PRIVATE SANITARY SEWER
TO SERVE

TRU HOTEL AT PLAZZIO

AS BUILTS

PRIVATE SANITARY SEWER PLANS FOR
TRU HOTEL AT PLAZZIO

SAN LINE 1

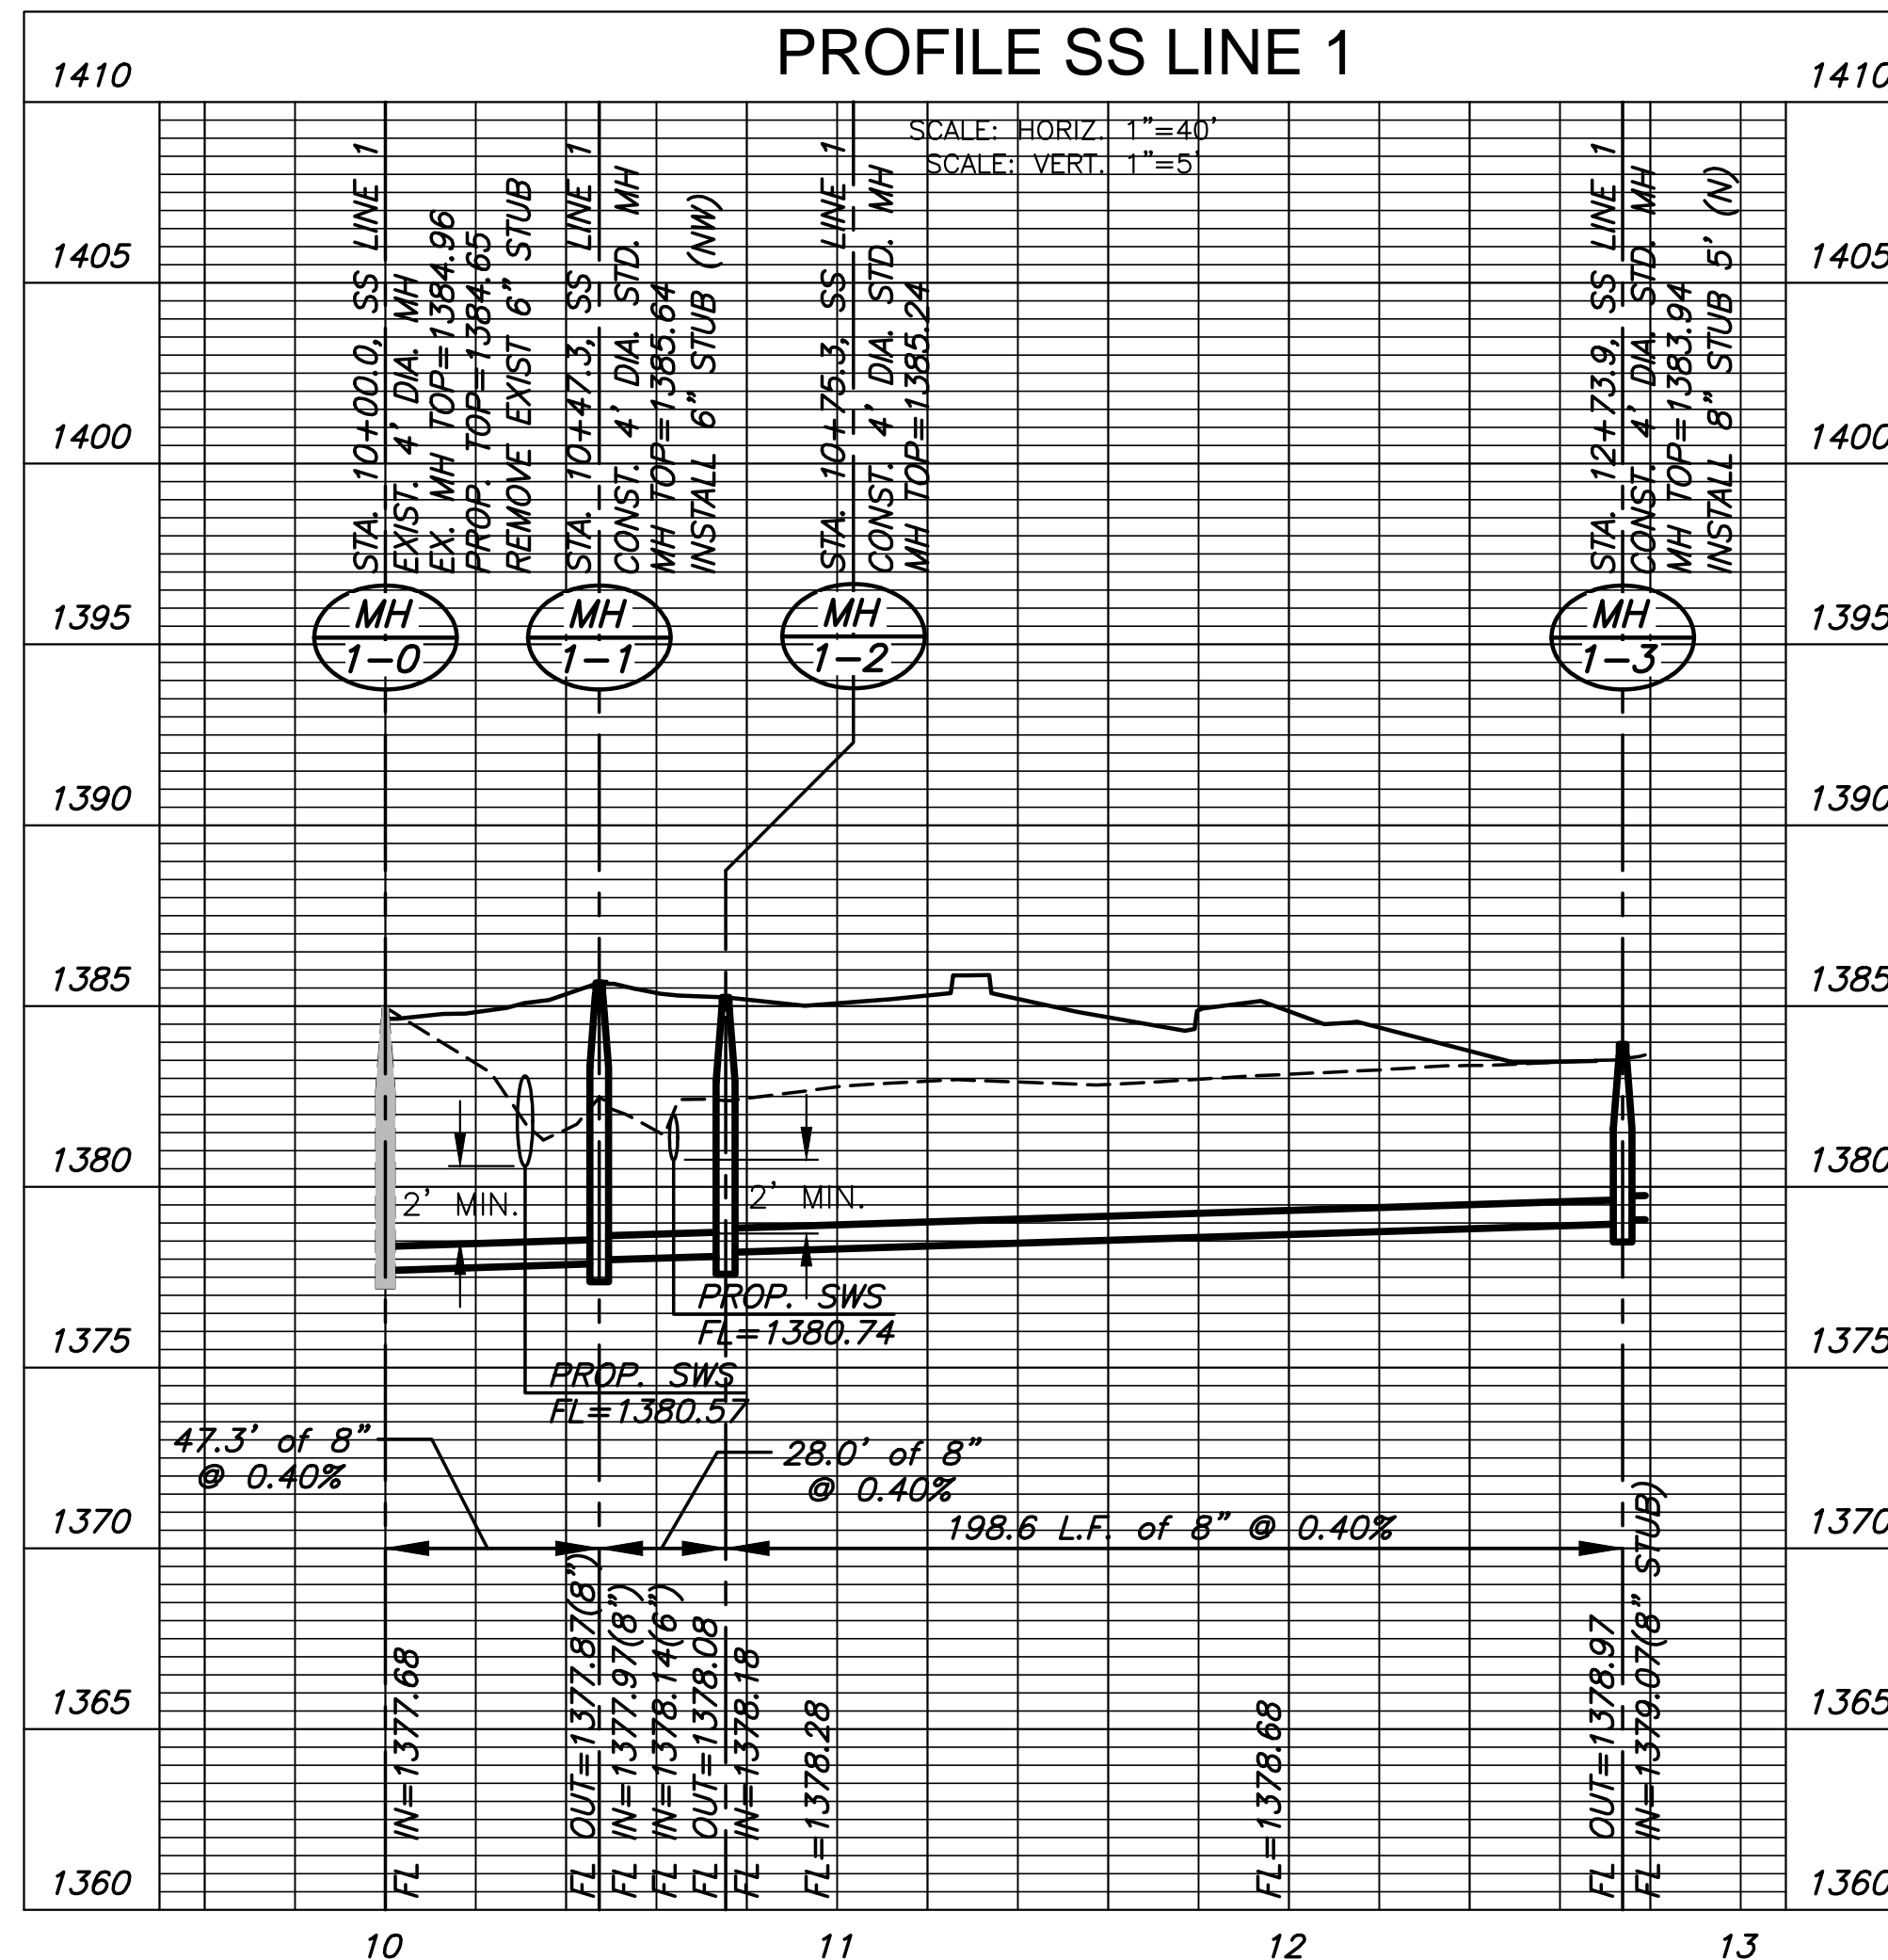
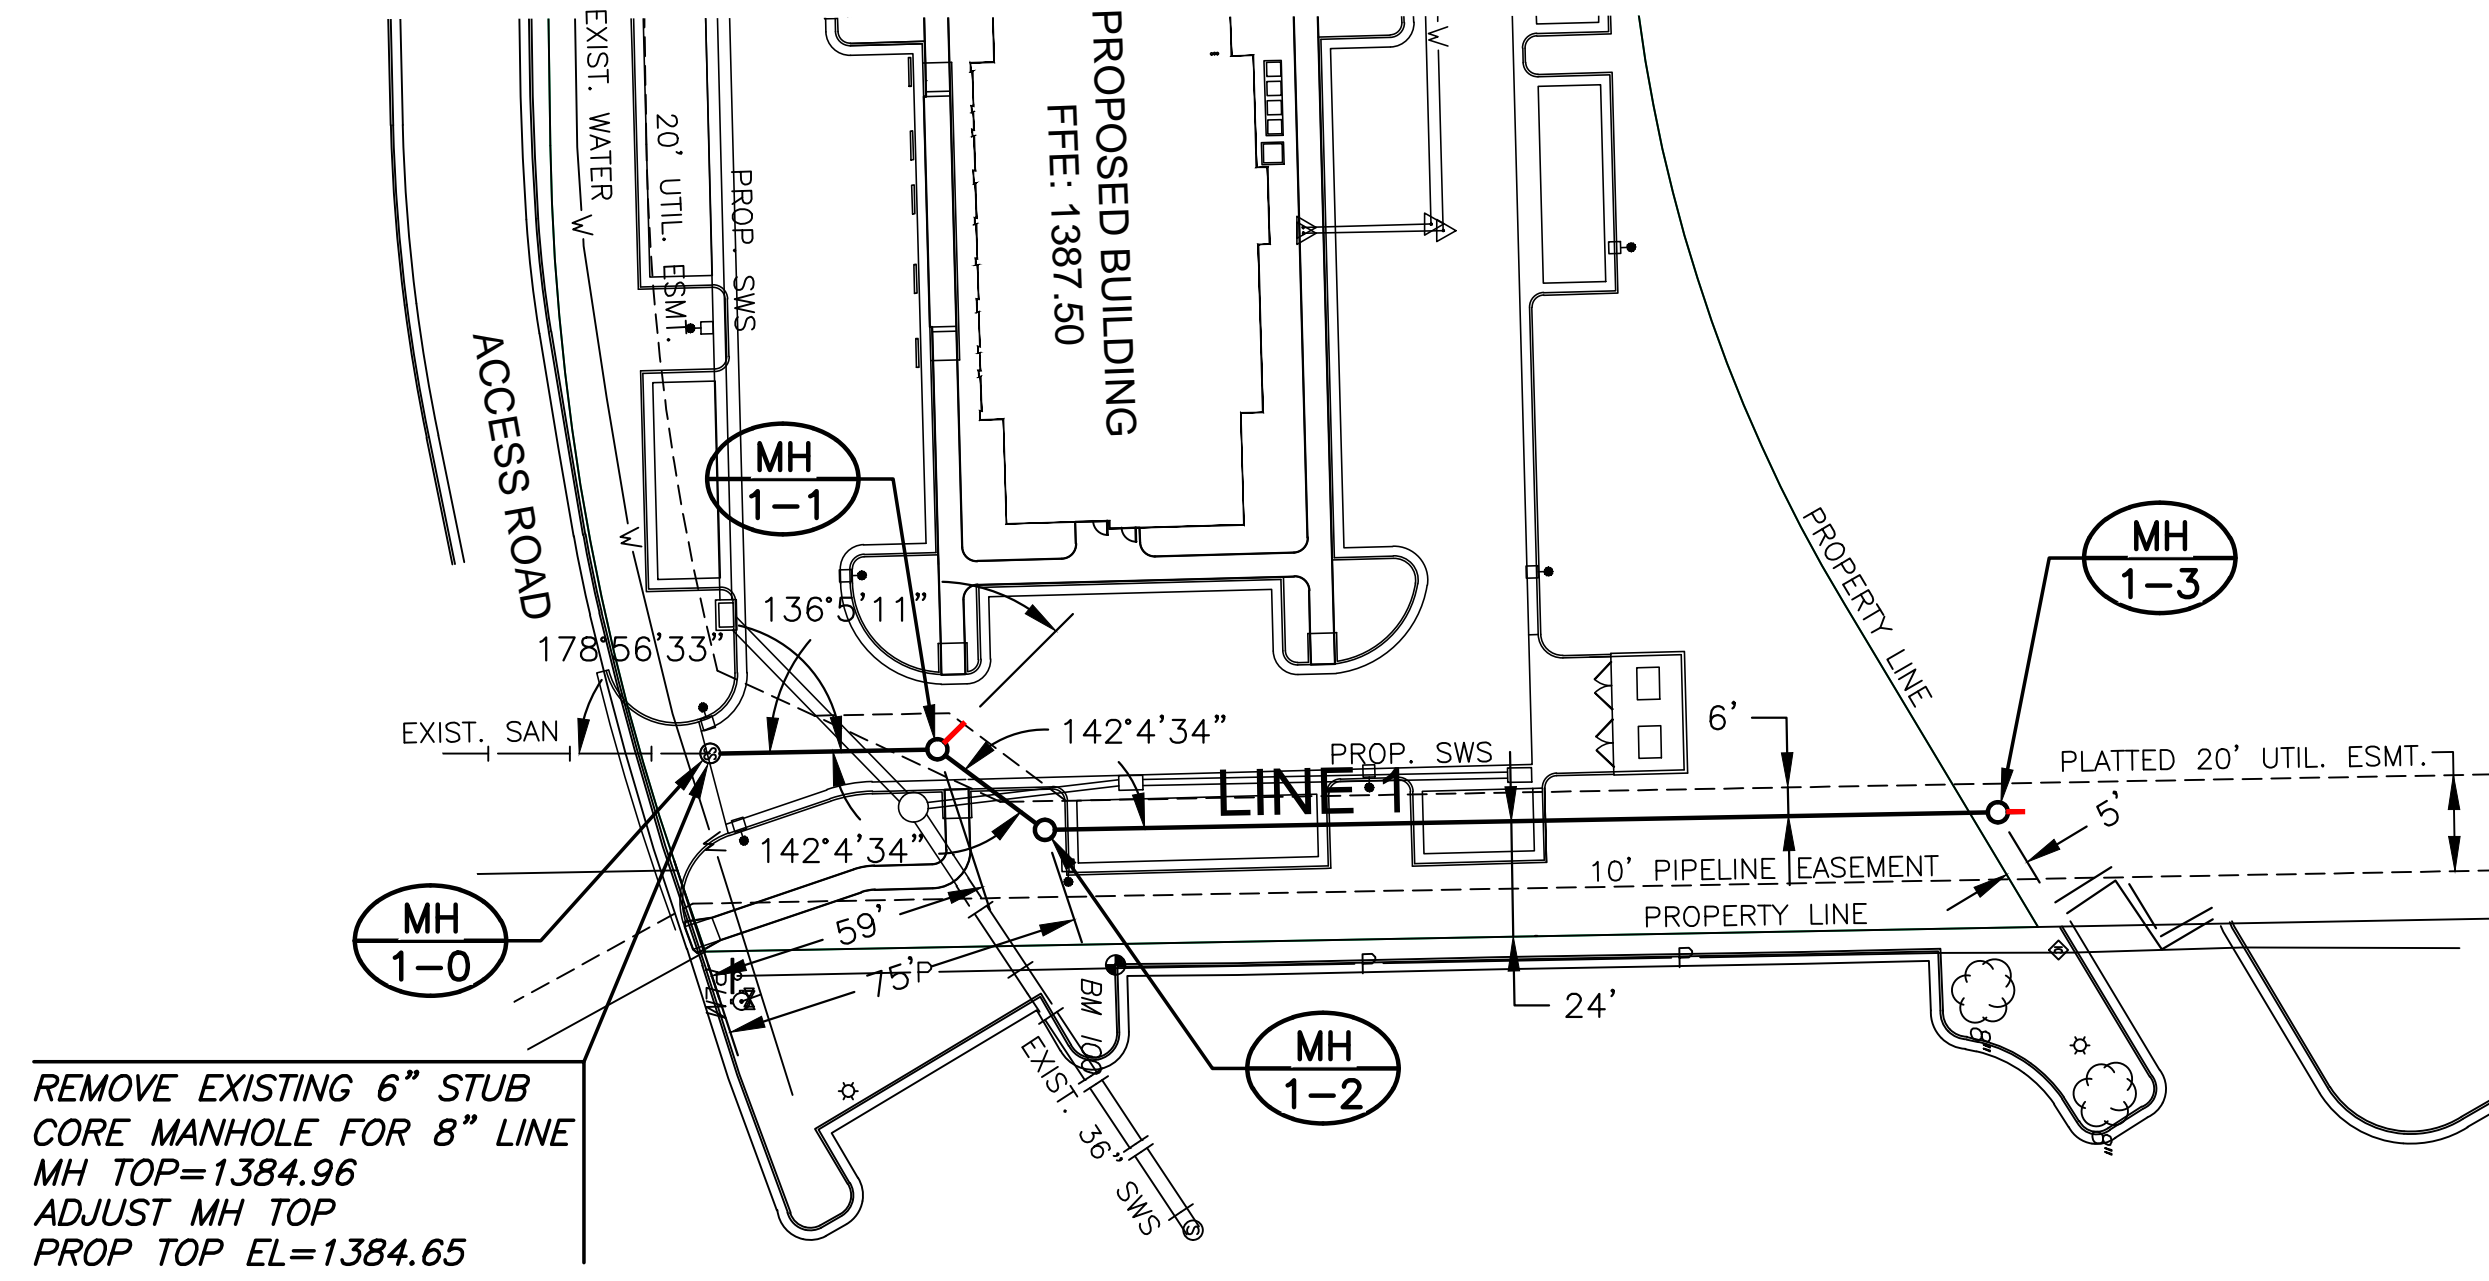
MANHOLE 1-1 HAS EXTRA HOLE WHICH WAS STUBBED OUT AND PLUGGED (SW) 6" pvc
